SAFETY RECALL BULLETIN

NHTSA RECALL 22V216

AUTOCAR, LLC SAFETY RECALL ACX-2201

Autocar, LLC has determined that a defect which relates to motor vehicle safety exists in certain Xpeditor (ACX) chassis. The anti-lock braking system (ABS) modulation valve wiring may be incorrect.

Figure 3, X2 Connector

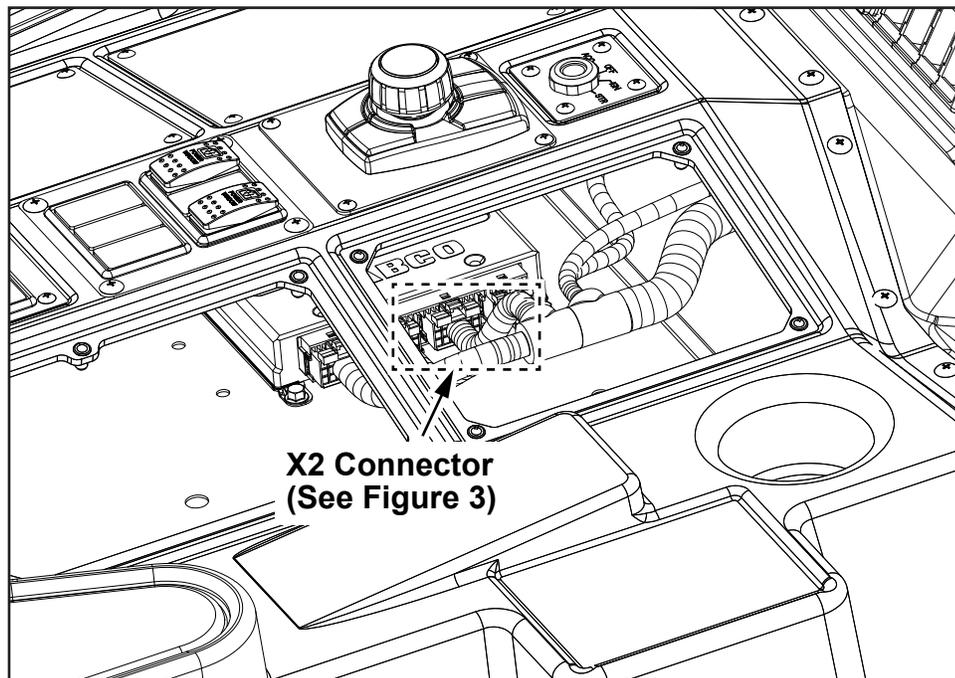
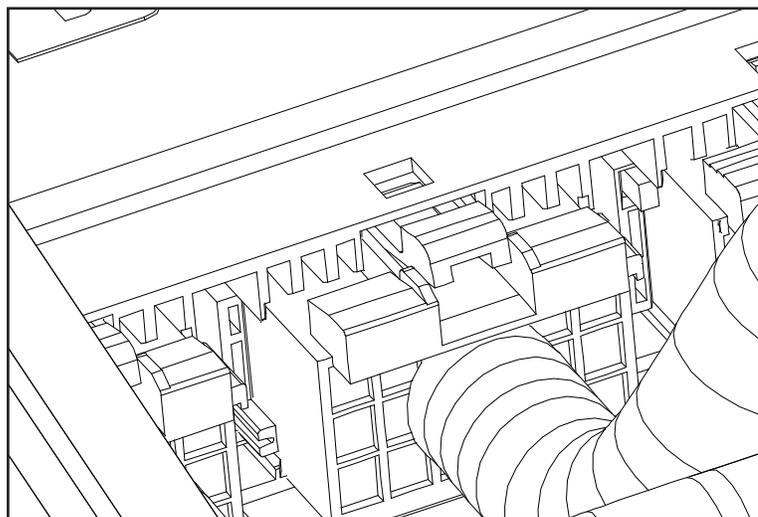
5. Locate and remove the X2 connector from the ABS controller (see Figures 2 and 3).

6. Verify the X2 connector cavity 3 wire 733-A and cavity 6 wire 732-A are properly pinned. If the X2 connector is properly pinned, no repair is required.

If the X2 connector is not properly pinned, adjust the pinning as required.(see *Figure 4*).

Figure 6

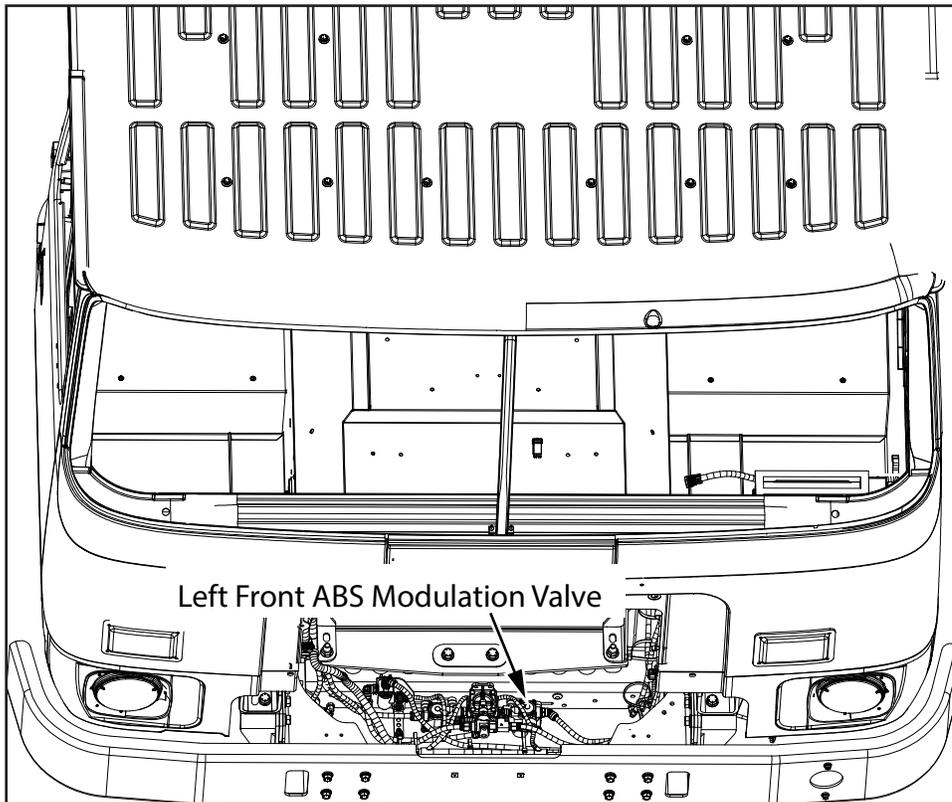
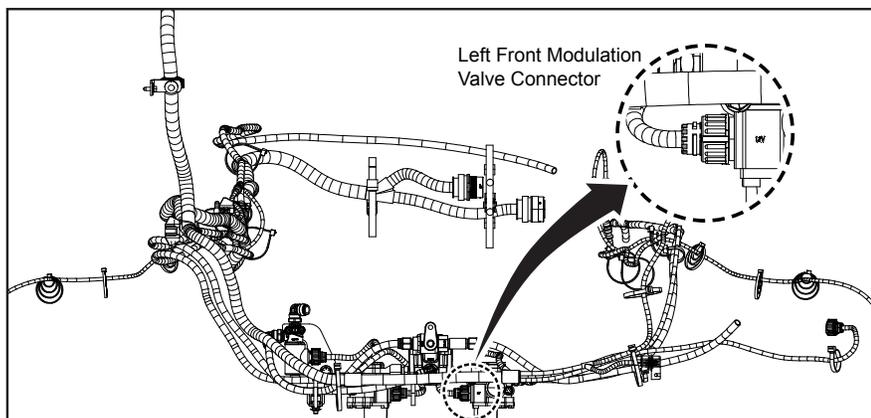
9. Locate the left front ABS modulation valve and wiring connector (see Figures 6 and 7)

10. Disconnect the left front ABS modulation wiring connector and verify the connector is properly pinned. If the connector is properly pinned, no repair is required. If the connector is not properly pinned, adjust the pinning as required (see *Figure 8*).

Cav	Wire	GA.	Type	Col.
1	732	16 GA	GXL	GN
2	734	16 GA	GXL	GN
3	733	16 GA	GXL	GN
